Our Ref: CARE 14/004
Your Ref:

14 November 2022

Cambridge, King's College Chapel (Diocese of Ely) Installation of PV panels

S façade from the far side of Great Court

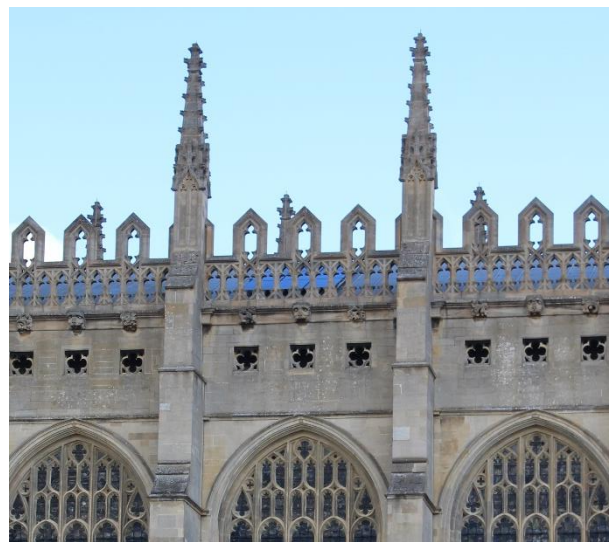
It has been acknowledged since the pre-application stage that the panels would be visible. The Council's earlier advice stated that glimpses of the panels from ground level should not have to dominate the views of the chapel, particularly if the panels are made from non-reflective materials and the scale of the lead bays is maintained. It was clear from the site visit that the chosen panels were visible and that they noticeably reflected light. The base colour is black but the material is sufficiently reflective that the apparent colour varies considerably under different light conditions, from white (reflecting white cloud), to mid-blue (reflecting cloudless sky) to dark blue-grey (under partly-obscured sun). By contrast, the range of variation of the adjacent lead was far less, varying from pale grey to mid grey and grey-blue. All these effects were seen on the site visit, which took place between noon and 1pm on a mostly sunny day with fast-moving white cloud and some duller intervals. The Council accepts that the sometimes glaring contrast between the lead and the panels is not the issue since, when installed, almost the entire visible surface of the roof would be covered by panels such that the lead would not be visible. Neither is the base colour itself the obvious problem. The issue is the reflectiveness of the panels.

In terms of size and arrangement, the panels are a reasonable match for the lead bays, the thin lines where they meet mimicking the rolls and lap joints of the lead bays. The resemblance is less convincing at top and bottom. There is nothing along the top edge that imitates the upstand of the roll along the ridge while the shadow under the bottom edge of the array is distinctly visible, both by being so dark and because of the contrast with whatever colour the panels are displaying. Attention is drawn to this in particular from about 50m away in the Great Court, where the shadow makes the bottom of the tracery piercing very noticeable next to the rest of the parapet openwork through which the panels can be seen, especially when they are reflecting paler colours. This effect is also visible on the north side from Trinity Lane and perhaps from some other vantage points on Clare and Trinity College premises but the impact is arguably less in these locations because the views are more incomplete and constrained by adjacent buildings. A selection of photographs illustrating the appearance of the panels from various locations and under different light conditions is included at appendix 1.

The Council noted that the panels are to be set on a new layer of sarking boards laid on top of the old ones thus raising them and the ridge higher than we observed. This is likely to make the shadow line at the bottom edge a little higher as seen through the parapet openings, although the shadow line will remain the same depth. Consideration could be given to lowering the posts to minimise the height of the top surface, subject to any consequential impact on the weatherproofing of the roof, especially in snow conditions.

The Council recommends that the applicants review the choice of solar collector. Rigid framed panels might not be the only option. The market should be checked for different colours and surfaces as there may be less reflective products or ones which could be laid directly on the leads. Technological improvements may have been fast enough since the proposed panels were

chosen that better-performing solar collectors might now be available. In addition, the applicants should look at ways to reduce the contrast as seen through the parapet tracery, for example by the addition of mesh.
